Technical Note TN-825 TM8000 Mobile radio Release 2 Upgrade Instructions

19 December 2003

Fitting the Watchdog timer

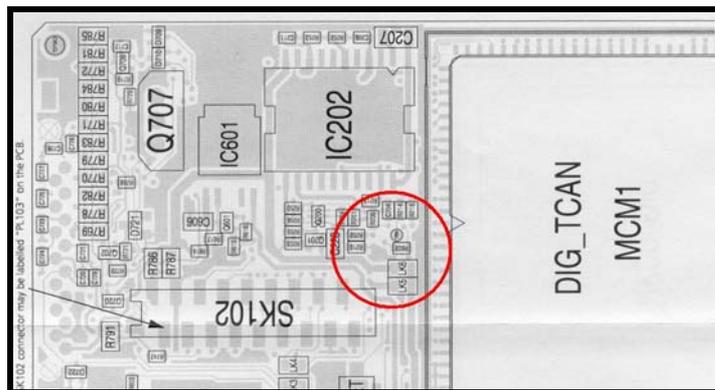
The watchdog timer provides the TM8100 radio with a non system error reset. Should the processor stop for longer than 1200mS the timer will restart the radio.

From introduction of Release 2 into manufacturing TEL will be making the change to always place the link for new radios built.

Retro-fitting the watchdog link is entirely optional. This means that if it is not fitted there will be no difference to current operation. However, if the added security of watchdog reset is desired then the decision can be made to fit the link.

The watchdog link is R602 located on the top side of the main board between TP200 & LK6. This is a zero ohm 0603 resistor. **IPN** 038-10000-00.

Note: Using the watchdog timer comes with a warning. A watchdog reset will cause a complete processor restart and hence also release the power supply latch signal momentarily.

If power supply LK1 is not fitted, or if the IGN or INT_OPT_PWR signals are not asserted at the time, then the radio will switch off with a watchdog reset and require a manual restart. Thus, the watchdog timer should only be used with special care paid to power link settings and system design if used in remote out-stations etc.
